Flour Bluff Gardens

Block 7, Lot 2R (Final Plat)

**Request for Plat Waiver
from the Sidewalk Construction Requirement**

Planning Commission Meeting
January 9, 2019

Flour Bluff Gardens, Block 7, Lot 2R Plat

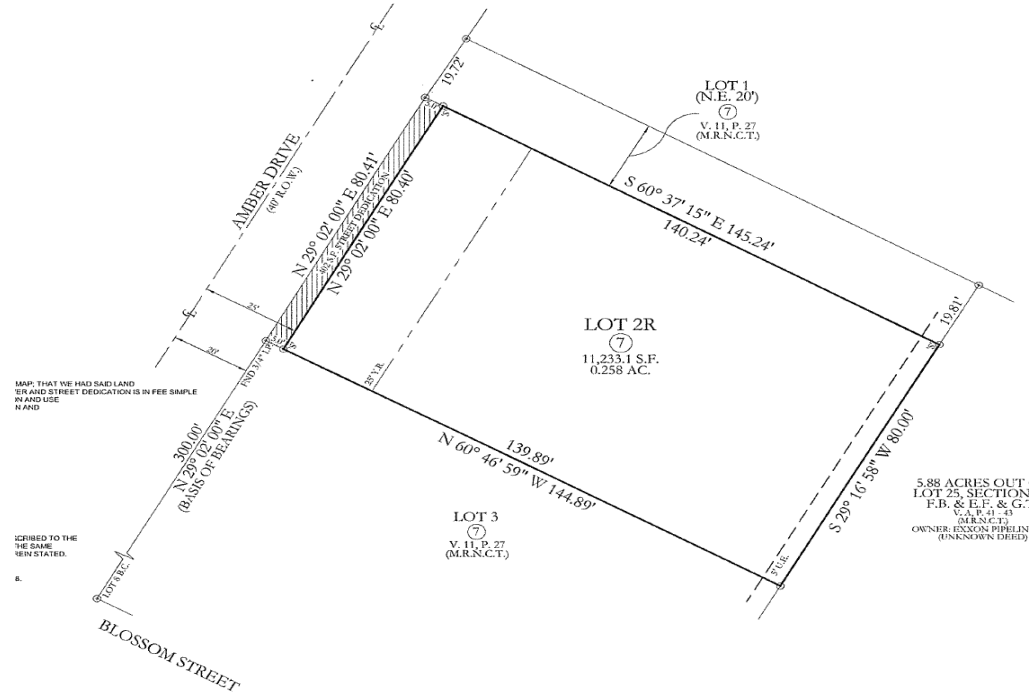
- Open drainage ditch in front of property; no room for sidewalk
- No sidewalks in the whole neighborhood along Amber Dr. (originally platted in 1947)
- Not on the ADA Master Plan
- No transit stops on Amber Dr.
- Waiver should not conflict with Comp Plan and purposes of UDC; not on UTP

- Property within walking distance of church
- Residential Single-Family 6 ("RS-6") zoning
- Plan CC
 - Vision for Transportation and Mobility: "connected networks of good streets and sidewalks, safe bicycle routes"

Staff recommends approval of the request for waiver from the sidewalk construction requirement.
